**PG&E Response to NRC Request for Additional Information Regarding License
Amendment Request 16-04, "Request to Adopt Emergency Action Level Schemes
Pursuant to NEI 99-01, Revision 6, 'Development of Emergency Action Levels for
Non-Passive Reactors'"**

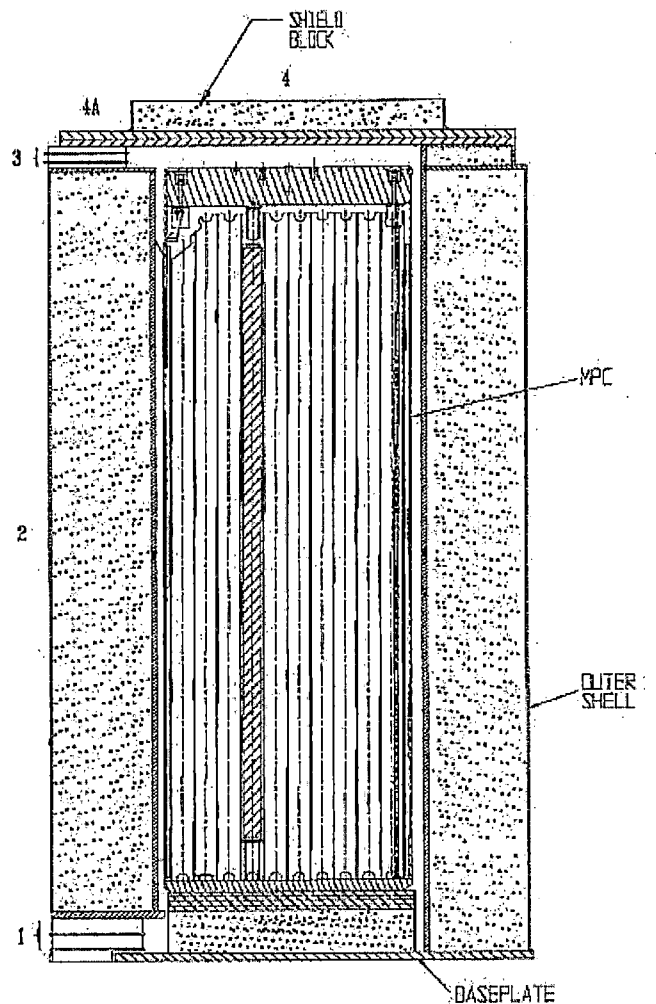
- a. The provided values are significantly below the expected threshold values provided in the endorsed guidance, which could result in an Unusual Event declaration for a dose that is only slightly above the maximum calculated dose rate values. Please explain, why the endorsed guidance of 2 times the technical specification values was not used or revise accordingly.*
- b. Concerning the above note relating to low burn-up fuel. The NRC staff could not determine the purpose of this note based on the information provided. Please explain if this note is intended to indicate that all current and future spent fuel casks will be only loaded with low burn-up fuel or revise accordingly.*

EAL EU1.1, Table E-1 was revised, as shown below, to establish surface dose rates that are two times the Updated Final Safety Analysis Report (UFSAR) Table 7.3-1A, "Surface and 1 Meter Dose Rates for the Overpack with an MPC-32 69,000 MWD/MTU and 5-Year Cooling."

<u>Table E-1 ISFSI Radiation Readings</u>		
Dose Point Location (see figure)	Surface Dose Rate (mRem/hour)	
1	Base vent	132
2	Mid plane	150
3	Top vent	140
4	Lid-center	34
4a	Lid-over top vents	267

PG&E revised the Basis section to reflect that these surface dose rates are two times the UFSAR Table 7.3-1A, consistent with the endorsed guidance.
